**Johnston County Public Schools
Clayton Middle School AHU 16 and 17 Replacement**

ADDENDUM NO. 1

DATE: April 09, 2025

ENGINEER: Dewberry Engineers Inc.
2610 Wycliff Road, Suite 410, Raleigh, NC 27607

PRODUCT: *Semi-Custom Modular Air Handling Units*
AHU-17

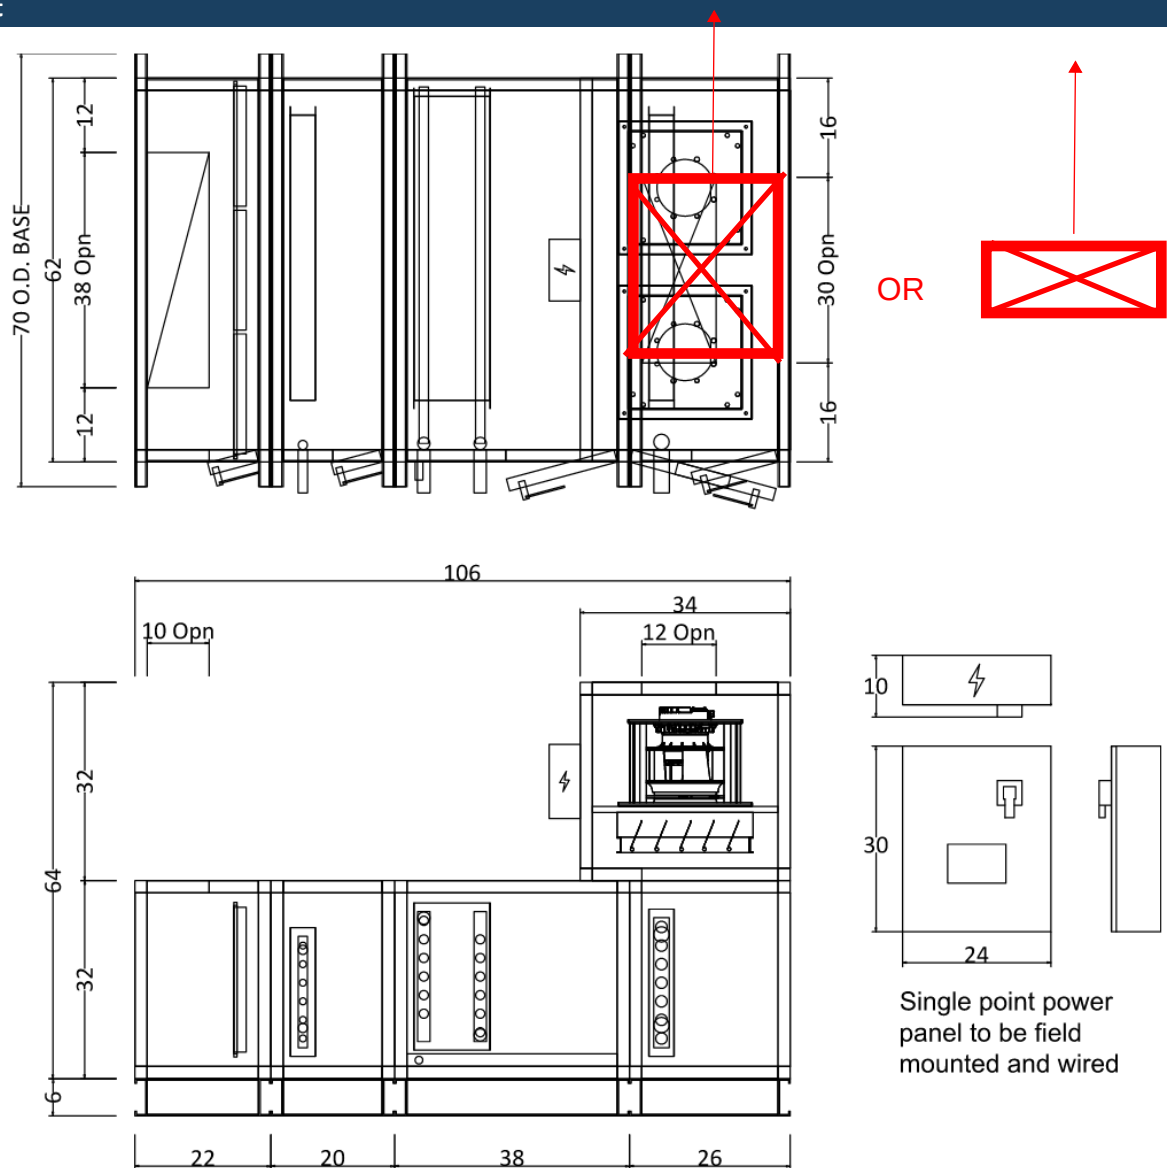
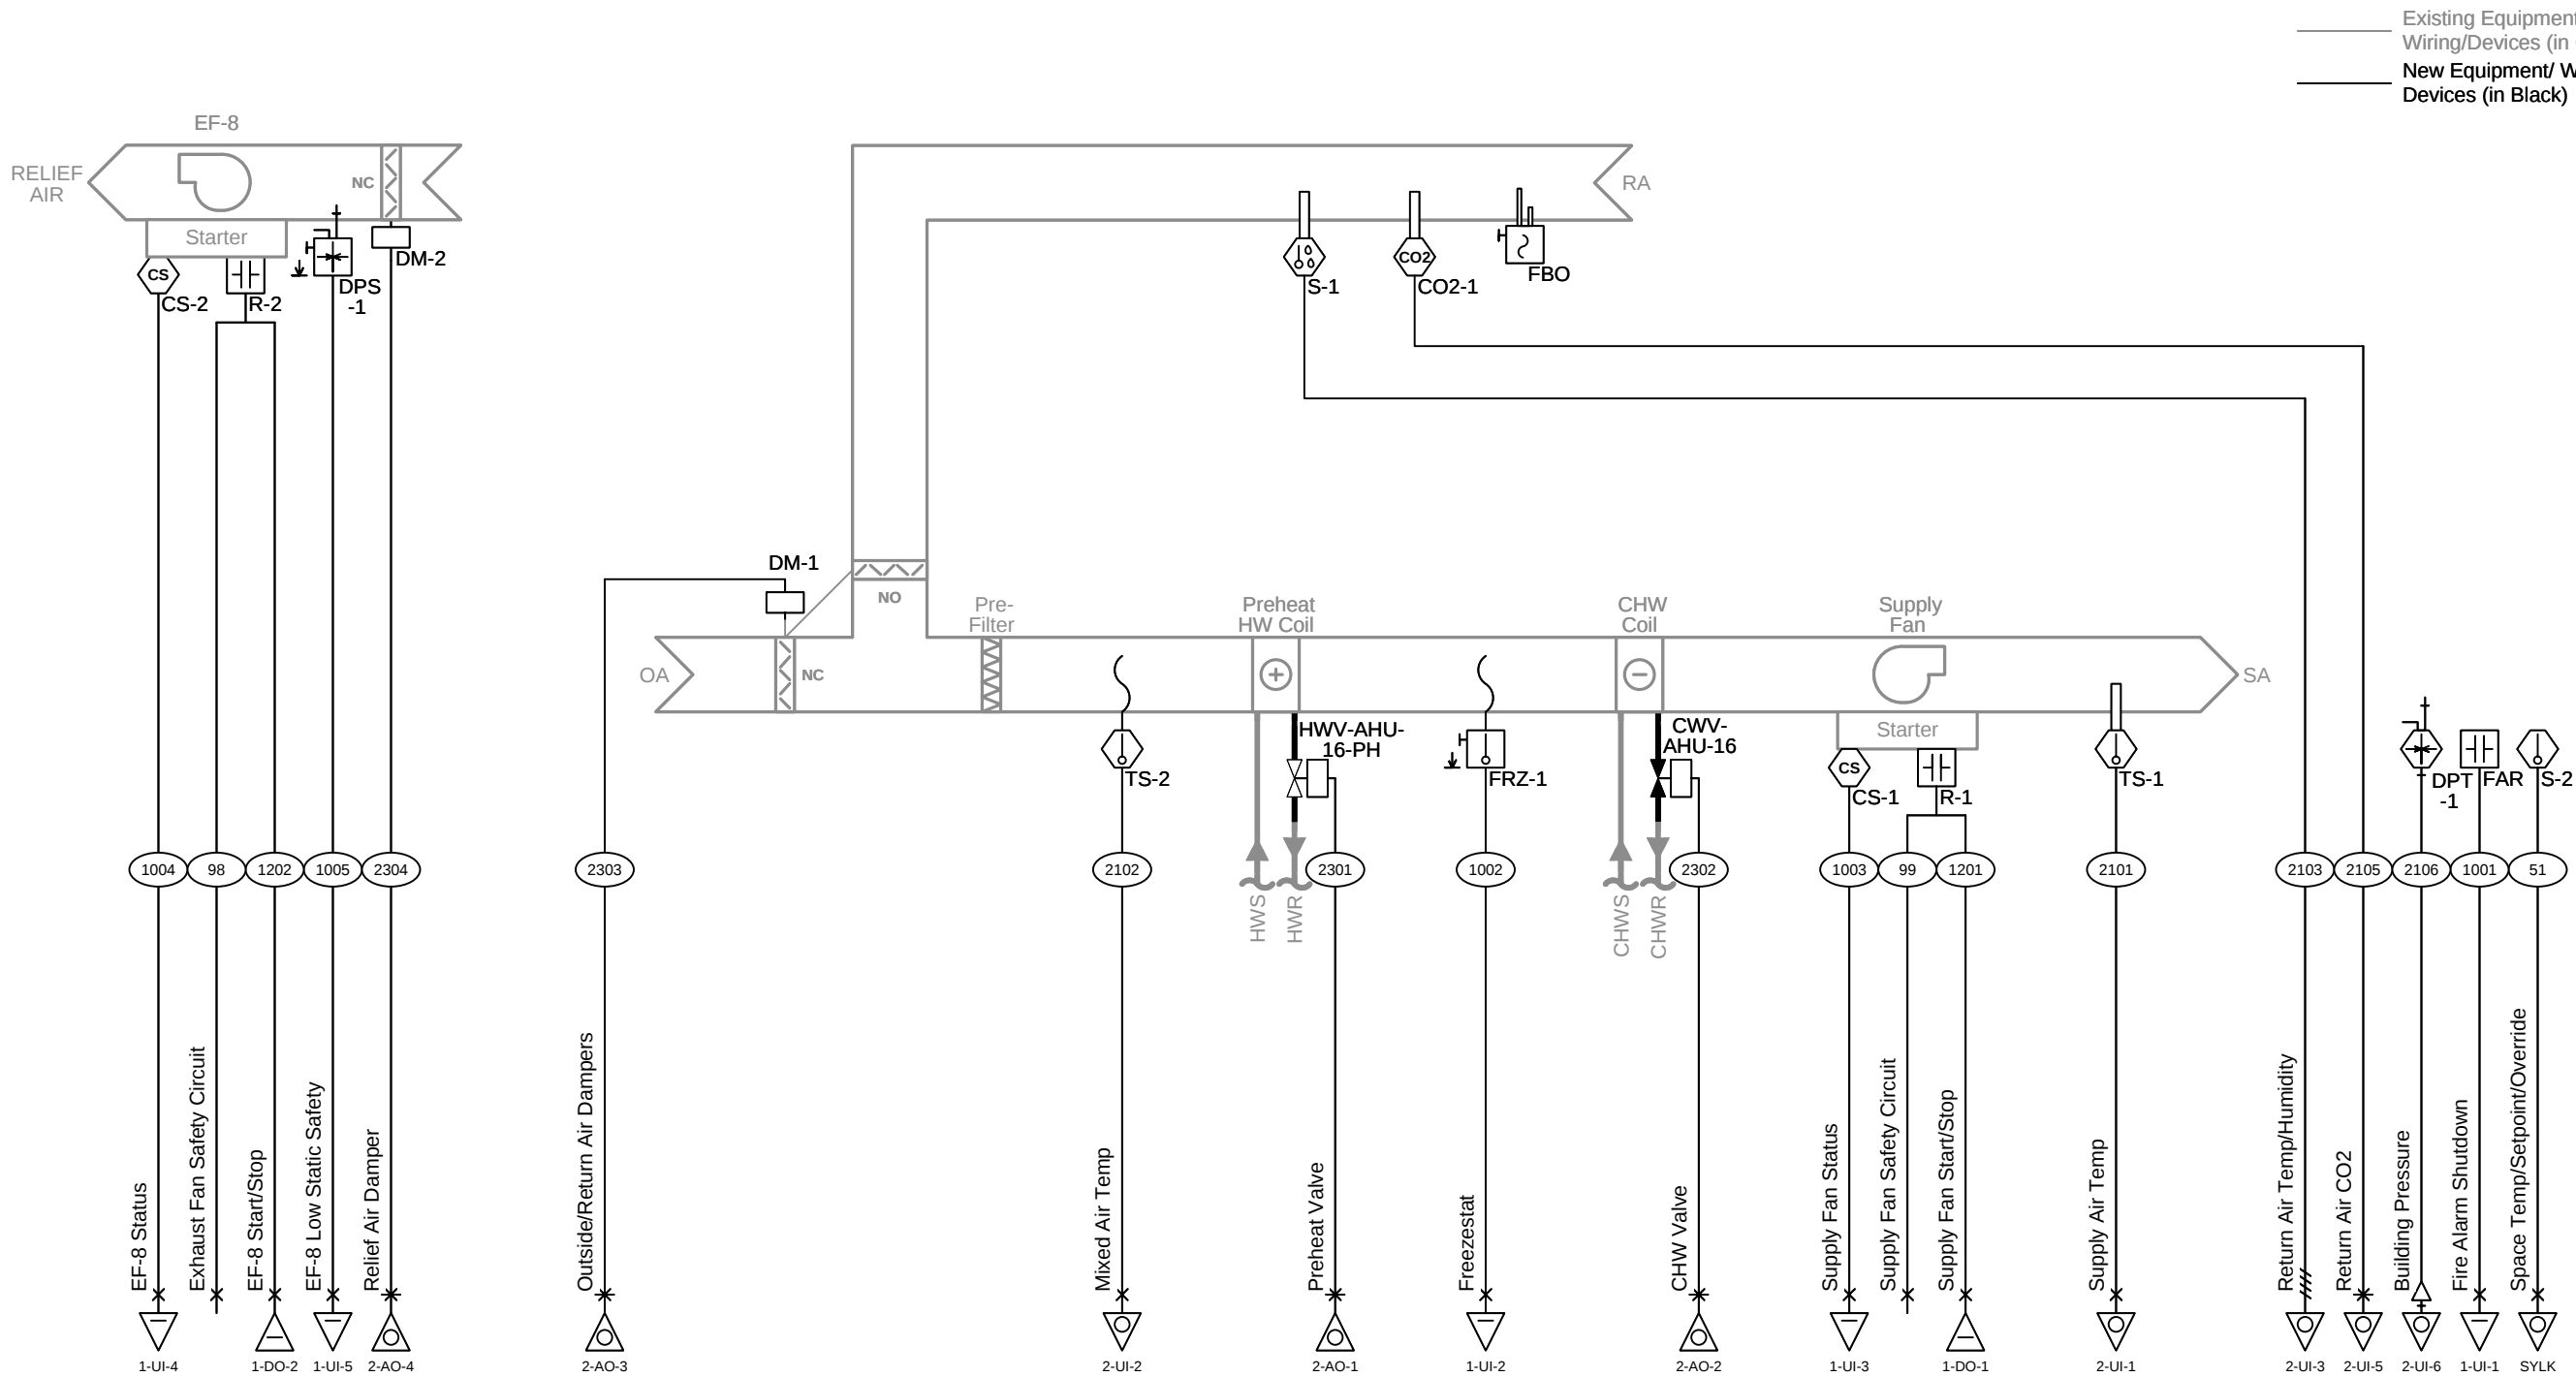
Change SA opening to
30x30 in lieu of 30 x 12 or
rotate 30x12 90 deg to
orient with existing duct
connection plan north of
unit.
